DOCUMENTATION TRANSMITTAL

Transmittal No: CIO-0043
Date: May 12, 1984

Documentation Description: Nonconformance Reports:

MIDLAND PROJECT
QUALITY ASSURANCE
DEPARTMENT

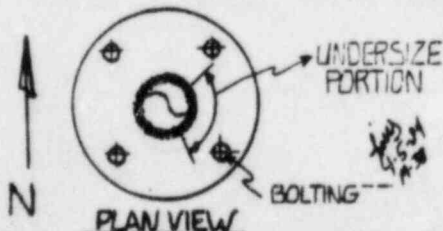
PQCI-P-1.90 REV 1 ACT#3.10C STATES: SOCKET WELD SIZES SHALL BE DETERMINED IN ACCORDANCE WITH TABLE 3.

TABLE 3 STATES THAT FOR 1" PIPE, SCH. 80, THE WELD SIZE (PIPE TO FLANGE) SHALL BE .2506".

CONTRARY TO THE ABOVE REQUIREMENTS, SOCKET WELD #3 ON LINE 1-2HBC-552 ON DRAWING FSK-M-2HBC-552-1 REV. 0 IS UNDERSIZED. VERIFIED WELD WITH DECIMAL GAUGE .2506 S/N# FG-.D35.

☐ YES☒ NO33A ADDITIONAL INFORMATION FIELD ENGR RECOMMENDS REWORK OF WELD
PER - G-27 AND SPEC M 204 REV 21 SECTION 5.4.4. TODD GROTH 4/18/84
4/25/84R GRUBICH 4/26/84

RECORD OF LOCATION 1 TEMPORARY ATTACHMENTS AND BASE METAL REPAIRS

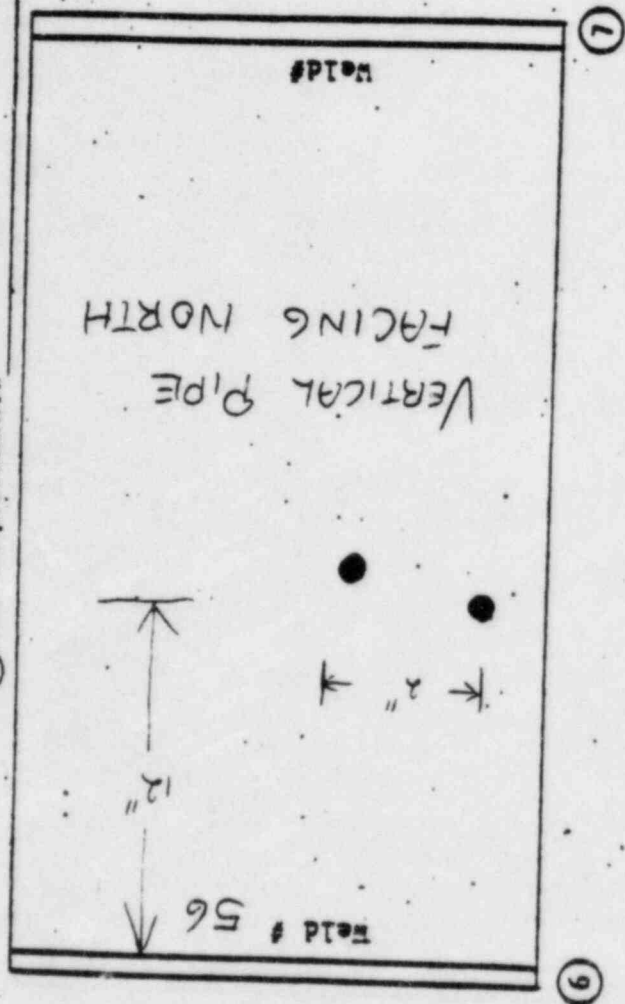
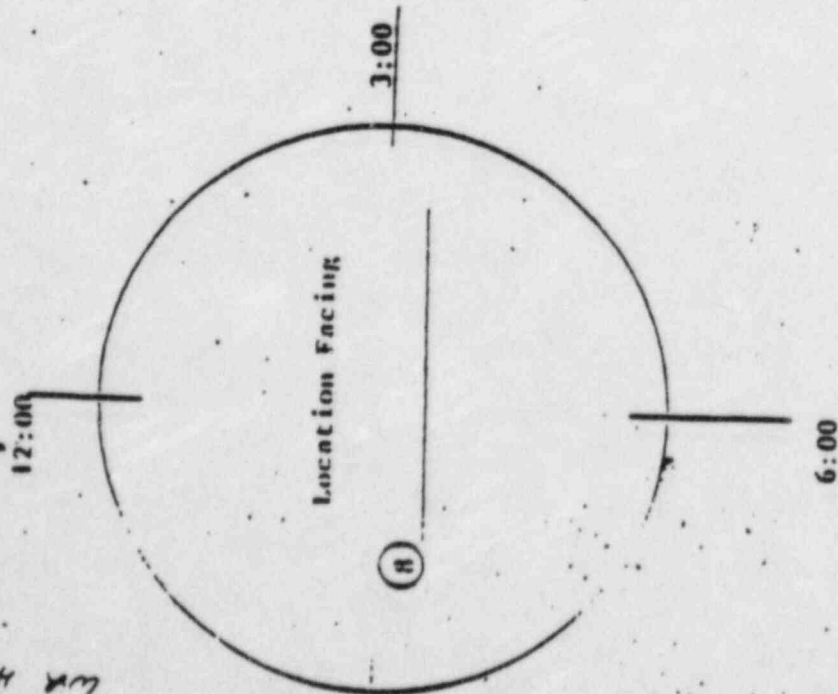
12 REQUIREMENT G27 ED-1 REV-2 STATES IN PART, ARC STRIKES WHICH ARE DETECTED
----- WHICH ARE NOT ASSOCIATED WITH A SPECIFIC WELD MAY BE EVALUATED
VISUALLY. ARC STRIKES AREAS WHICH ARE FREE OF CRACKS AND DO NOT INFRINGE
UPON MINIMUM WALL THICKNESS MAY BE USED AS IS.

13 NONCONFORMANCE CONTRARY TO THE ABOVE, ON SPOOL 2 OBC-2-S-634-4-1, TWO
ARC STRIKES EXIST. DUE TO METAL BUILD-UP AT THE CENTER OF BOTH ARC STRIKES
CRACKING IS INDETERMINATE.

SEE ATTACHED PAGE FOR
LOCATION

SCE NO. C-02891-V

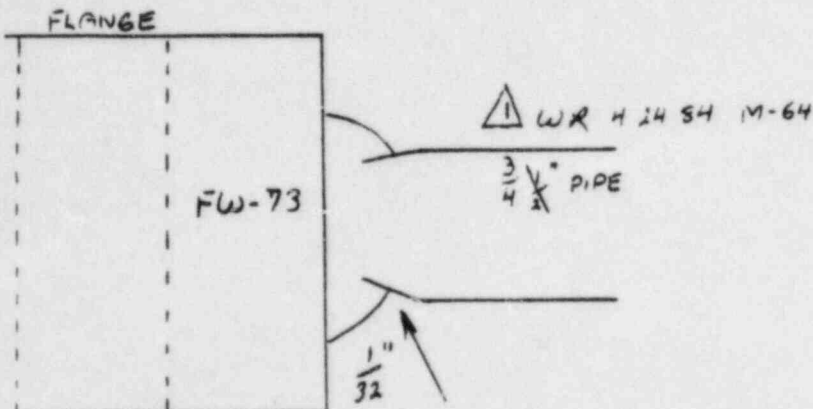
12 REQUIREMENT M-481 REV 25 NOTE 22, STATES IN PART, WHERE THREADED CONNECTIONS ARE SEALWELDED - - - - EXPOSED THREADS SHALL BE ENTIRELY COVERED BY WELD METAL.
M-204 REV-21 STATES IN PART, (PARA 5.2.6) MINIMUM WALL THICKNESS FOR FABRICATED ASSEMBLIES AS FINALLY FABRICATED SHALL BE AT LEAST:
A. 87 1/2% OF THE NOMINAL WALL THICKNESS FOR PIPE SPECIFIED BY NOMINAL WALL.
FOR PCT REQUIREMENTS SEE ACTIVITY 317 LI. A KRS-4-84(M-4)

13 NONCONFORMANCE CONTRARY TO THE ABOVE, AT FW-73 THE EXPOSED THREADS WERE REMOVED BY GRINDING, REDUCING THE BASE METAL FROM THE 3/4" PIPE IN EXCESS OF 1/32" AT THE TOE OF THE WELD, WHICH EXCEEDS THE DEPTH ALLOWANCE OF .019" AND VIOLATES MIN-WALL.
